802.1AX -- Link Aggregation:

Editor's Report: July 2017

Draft 0.1

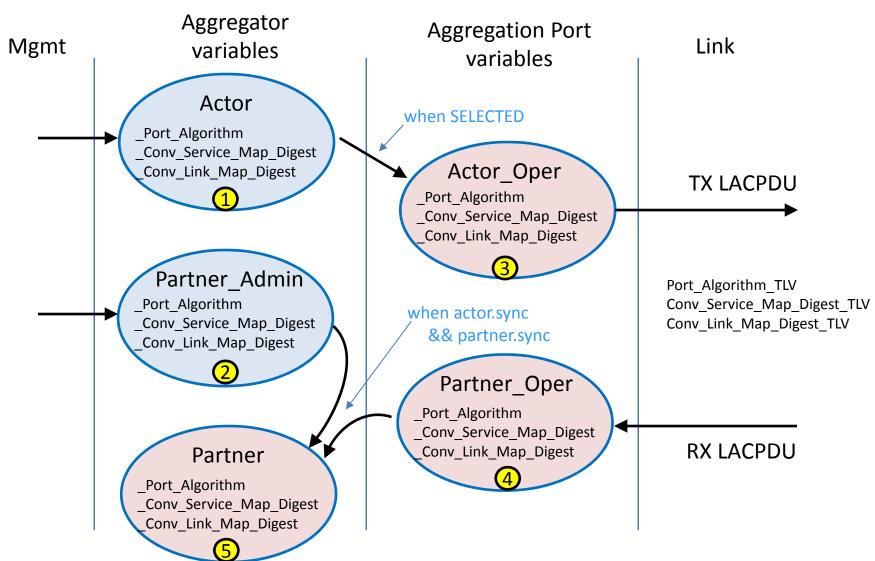
Mux/WTR comments

- Comments to be discussed
 - Transition with "|| (Wtr_timeout == 0)"?: 29, 192
 - NTT in DETACHED?: 9
 - Optional WTR?: 35, 38
 - Timer semantics and names?: 29, 33, 30, 31
 - Detached when non-revertive?: 139, 177, 72
 - Coupled_control and COLLECTING?: 146
